# Memorandum

**To:** Craig Batchelar  
**From:** Judd Speedy  
**Copy:** Jandre van Zyl, Brian Palmer, Helen Caley  
**Subject:** Allied Asphalt - Beca Resource Consent Responses

**Date:** 26 April 2023  
**Our Ref:** 3936244-159207228-2244

**Allied Asphalt, 54 Aerodrome Rd, Mount Maunganui**  
**Stormwater and trade waste treatment solutions summary**

**Title**  
 Site layout with  
 environmental controls

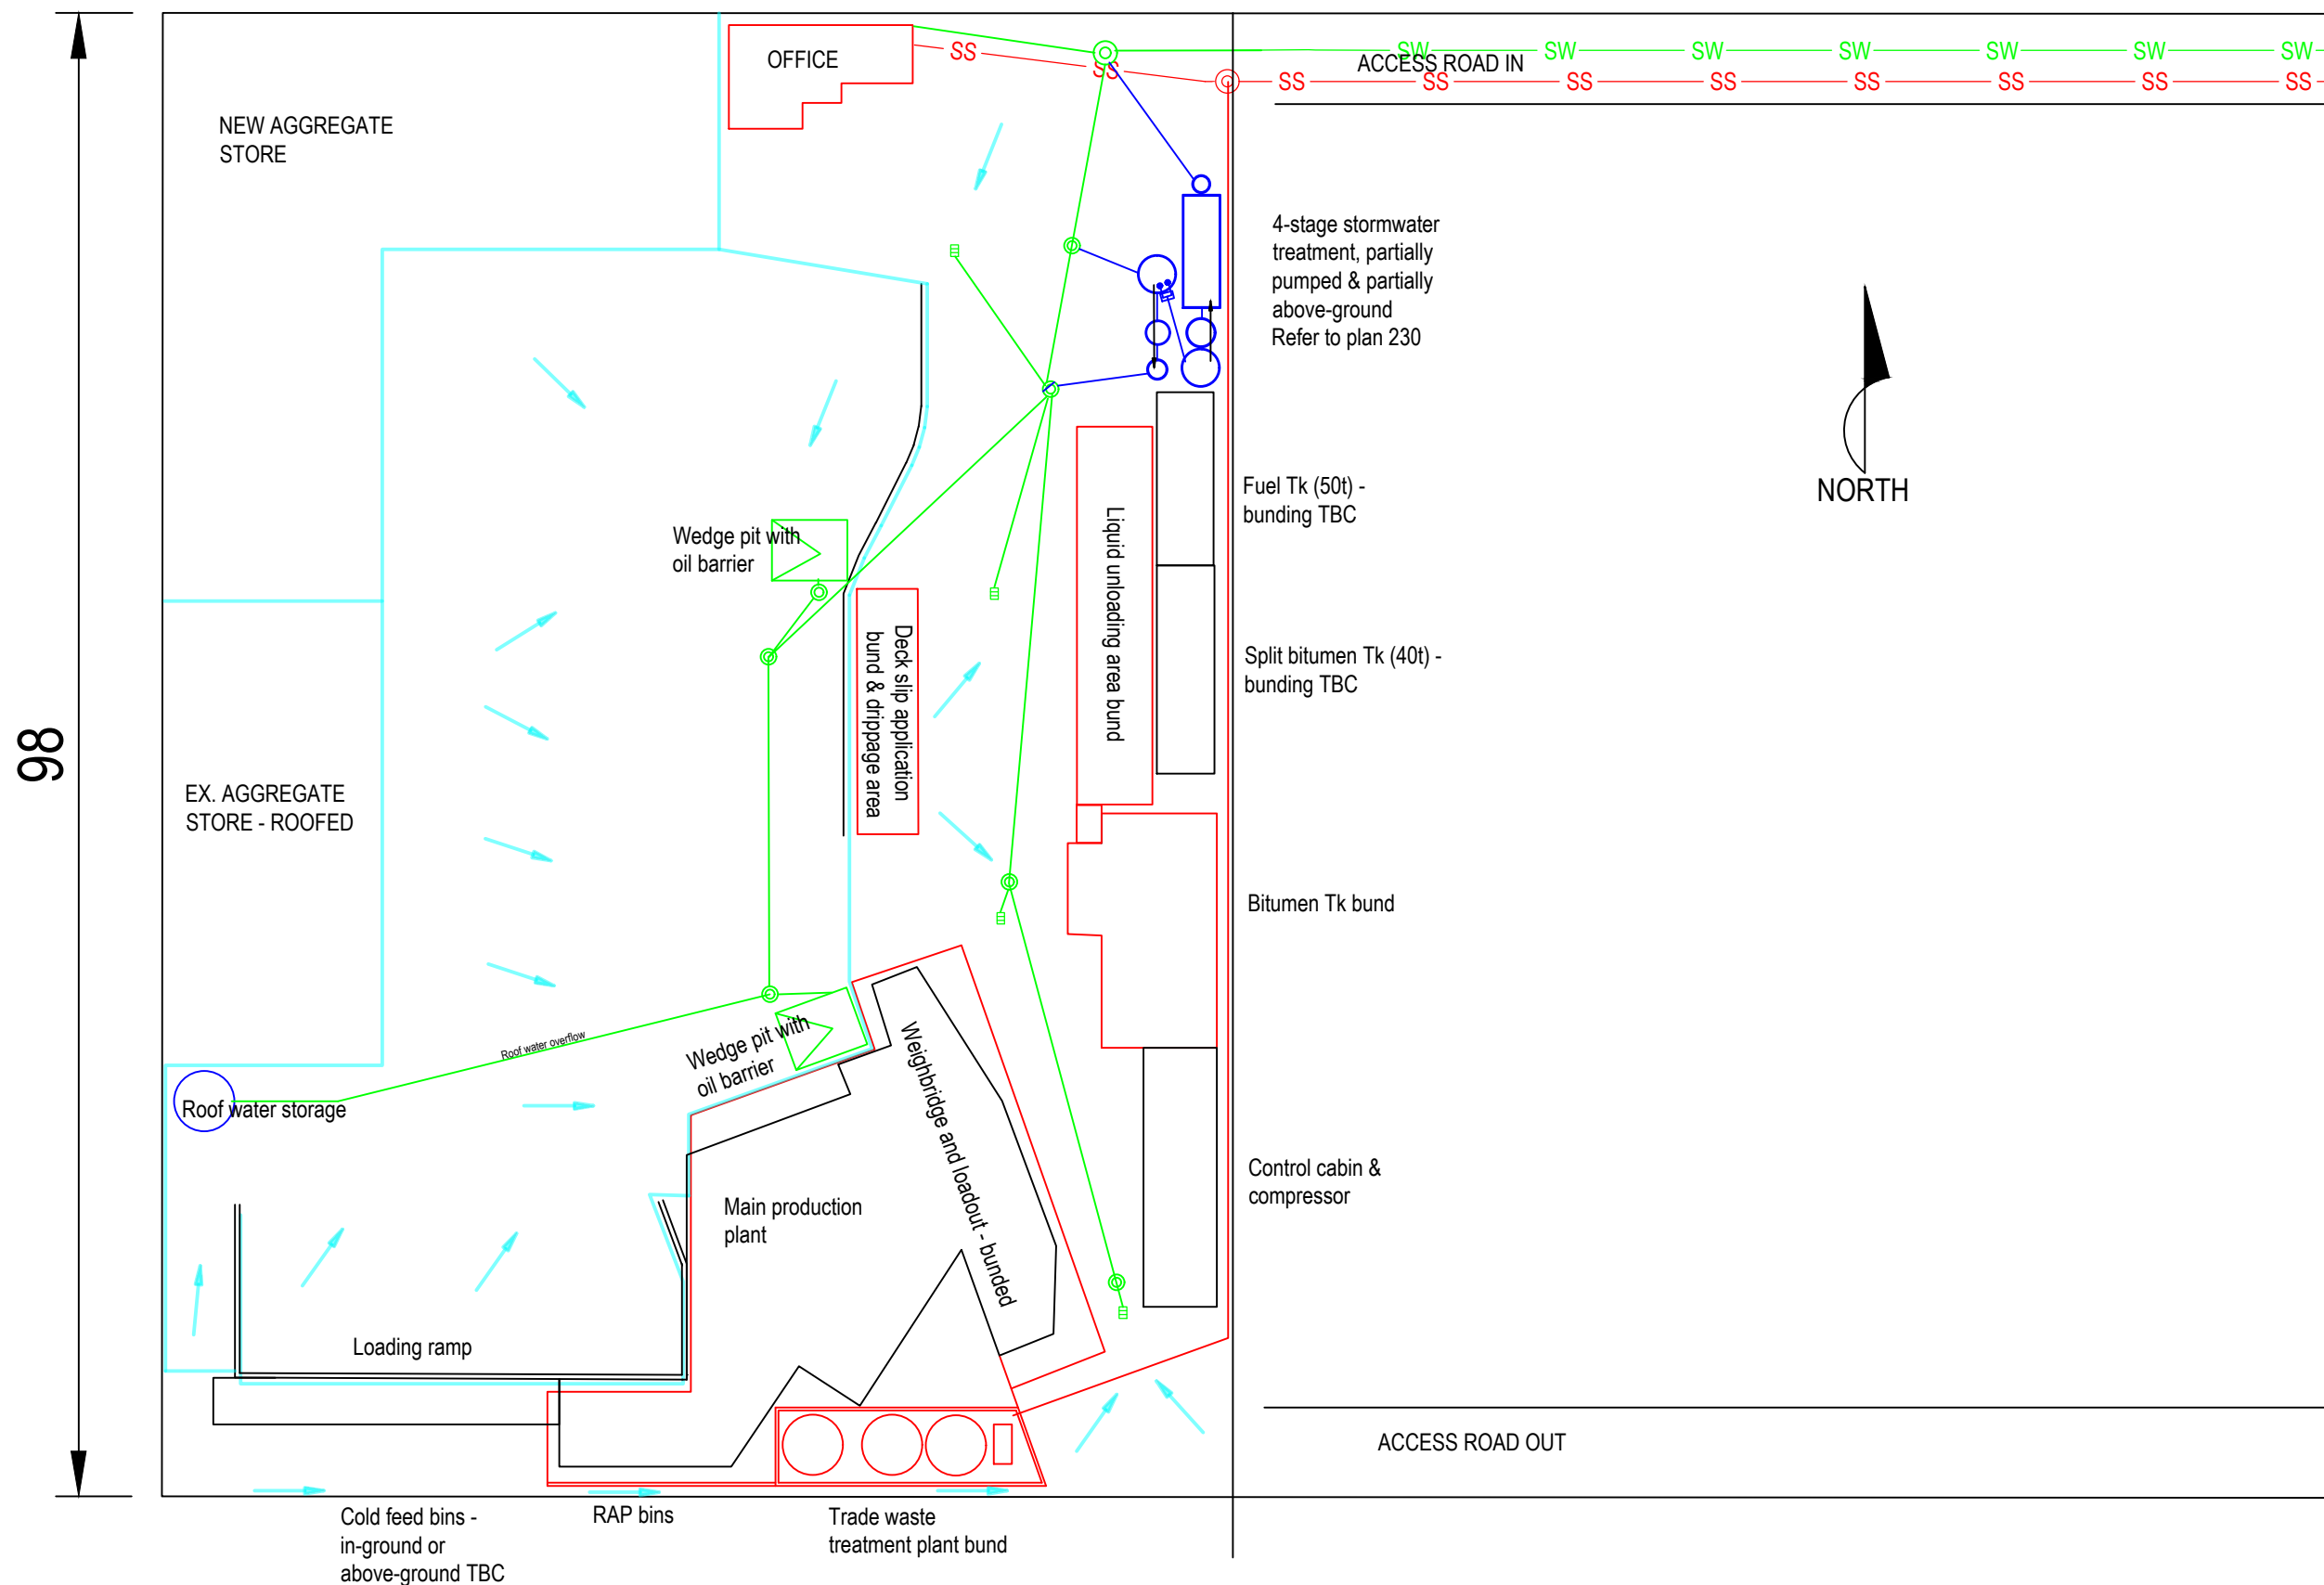
1. *Please provide an initial hydraulic assessment to ensure the stormwater treatment proprietary device has sufficient hydraulic head to drive the intended operations effectively.*

2. *Information on the propriety device and the treatment provisions is required to understand how the system will perform to the permitted activity standards for water quality.*

An initial assessment of the stormwater network has been undertaken, assuming a 350mm required head loss for the treatment device e.g., as indicated by Stormfilter 360, their devices can meet the hydraulic effect.

Refer to the proposed stormwater treatment system from IWS attached as an appendix.

Area segregation is a key strategy within the design, as shown in the sketch below.

It is proposed that the high-load areas pass through wedge pits to allow initial removal of the larger solids. These wedge pits can be cleaned on a frequent (daily) basis using the site's front-end loader.

The stormwater treatment solution becomes common to all run-off downstream of the wedge pits. A multi-stage stormwater treatment solution is proposed for the site focusing on the range of contaminants that are anticipated – these being elevated suspended solids, slightly elevated organic load, Petroleum Hydrocarbons traces and elevated heavy metals in particulate and dissolved form.
